City of Santa Fe, New Mexico

memo

2025-010295-HDRB, 234 Irvine St, Westside-Guadalupe Historic District, contributing, Samantha Greenberg, agent for Edan Kark, owner, requests a status review with primary façade designation, if applicable, for a residential structure and requests a status downgrade for an accessory structure.

Figure 4: Unpermitted work on the property.

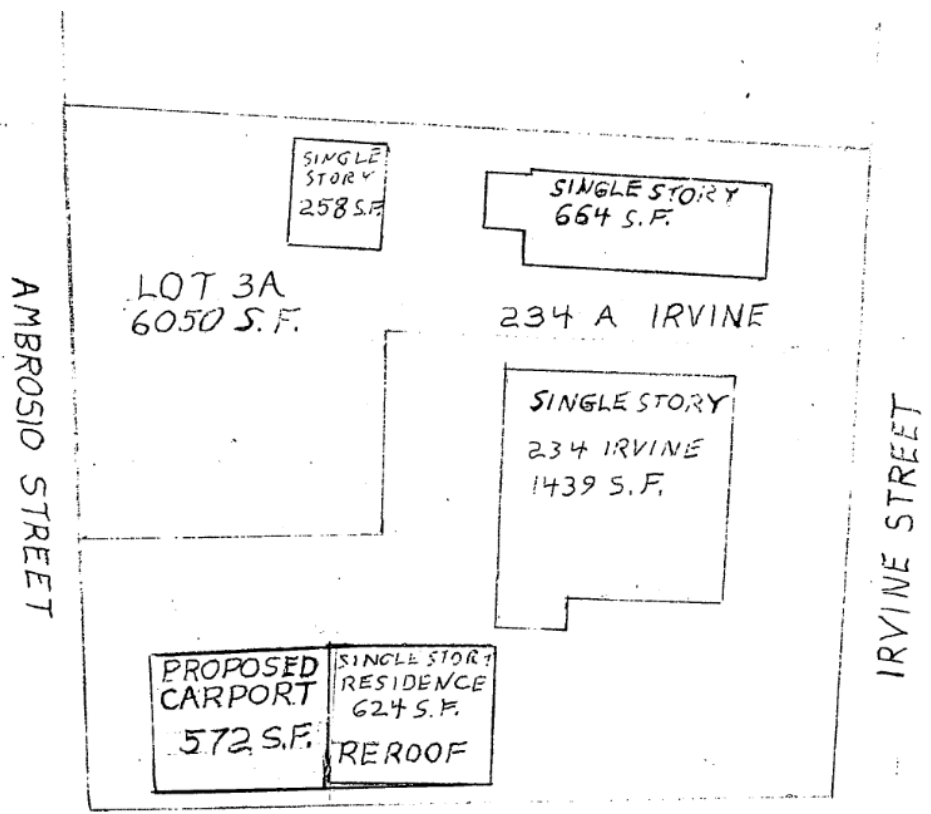
As of 2025, the unpermitted work on the property includes the following modifications:

1. Installation of the shed at the southwest corner.
2. Enclosure of accessory structure carport (subject of the 2019 red tag).
3. Construction of a porch on the west side of the contributing house between 2008 and 2014.
4. The enclosed porch area on the west side of the house (shows as a porch in 1985 HCPI), the second enclosed porch on the west side of the house added and enclosed after the 1985 HCPI.
5. Alterations to the front porch area on the east façade (brick with shed roof in 1985 HCPI and wood frame in 2007).
6. An addition/enclosed porch on the north elevation,
7. Connection between the two residences of unit A (per 2010 drawing), and
8. Increase of the wall height.

Please refer to Figures 4-10 for a visual representation of the progression of development on the property. Per section 14-5.2(C)(2)(f) *If a property owner makes changes to a structure without the proper city approvals which result in the lowering of the structure's status, staff or the board may require the property owner to restore the structure such that its former status is restored.*

Figure 11: Façade Map

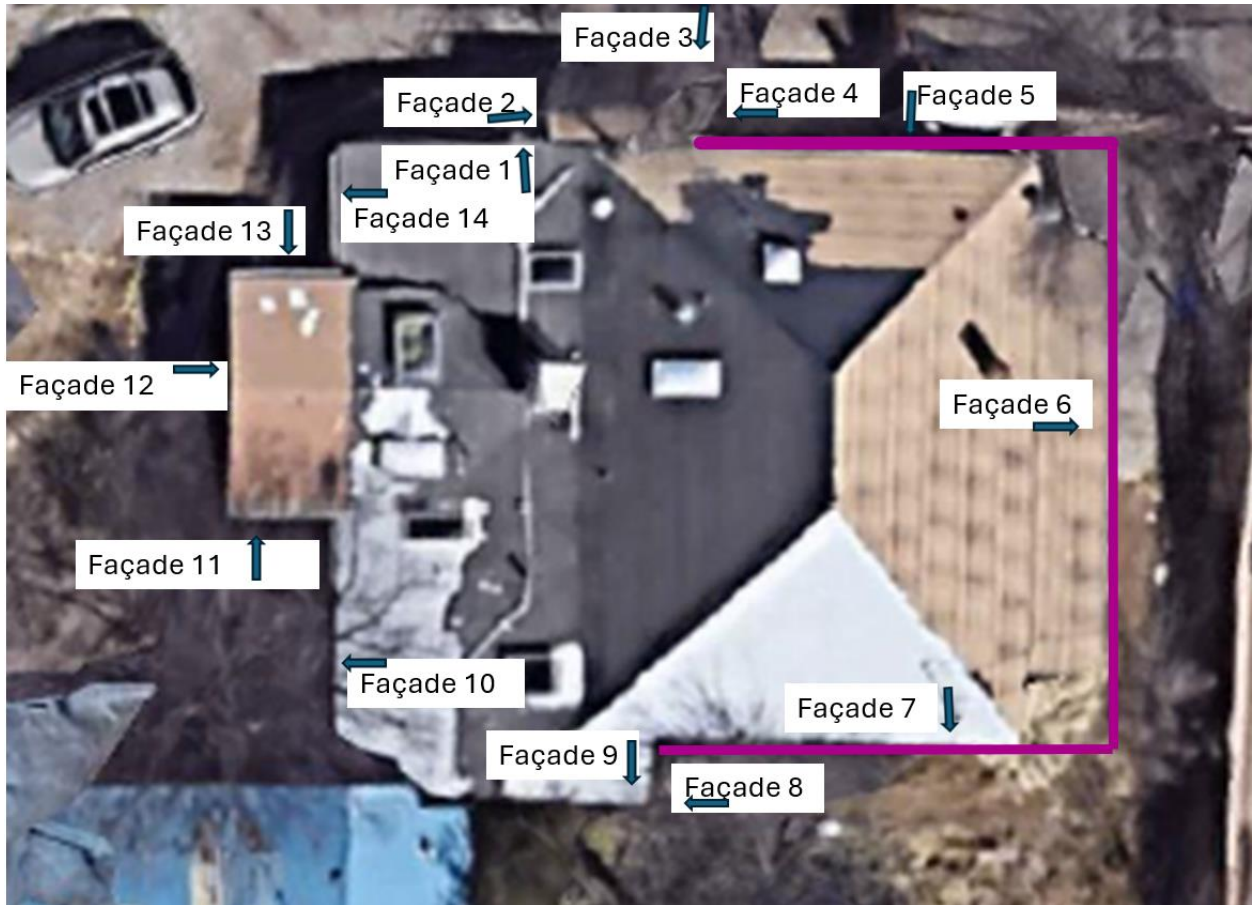
Staff recommends the main residence be maintained as contributing. While the structure has been modified and altered over the years, several of its distinctive historic properties are preserved, particularly on the north, east, and south facades. Per the HCPI, the property is part of the late 19th century, 1887, “Irvine Addition” which was the first subdivision on the west side of Santa Fe. The core of the residence remains distinctive, particularly the inset windows and the pitched hip roof on the adobe structure. Staff recommends the primary façades as the north, east, and south facades (facades 5, 6, and 7 respectively) which hold the original footprint of the residence, the inset wood windows with lead lozenge patterns and the original roof line of the building with the exceptions of the non-historic doors and windows and the non-historic east elevation porch.

The designation record of the accessory structure is inconsistent. Staff recommends downgrading/designating its status to non-contributing. Although the accessory dwelling structure was 50 years old at the time of the 2010 case, it was listed as non-contributing then. Currently, it is listed as contributing on the city’s map, but there has been no additional status review since 2010, and staff cannot identify why it is listed on the map as contributing. Based on the findings in the 2010 case, extensive alterations, little historical value, and because the enclosure of the 572 sq. ft. carport on the 624 sq. ft. (in 2010) structure was based off the non-contributing status, staff recommends that the accessory dwelling unit be officially designated as non-contributing.

Staff recommends the yard wall be designated as non-contributing due to age.

Staff recommends the historic status of the residential structure be retained as contributing with the primary façades designated as the north, east, and south facades (facades 5, 6, and 7 respectively). While some modifications have been made, these three (3) facades hold the original footprint and historic details of the residence, including the inset wood windows with lead lozenge

patterns and the original roof line of the building. Staff recommends excluding the non-historic doors and windows and the non-historic east elevation porch from the designation.
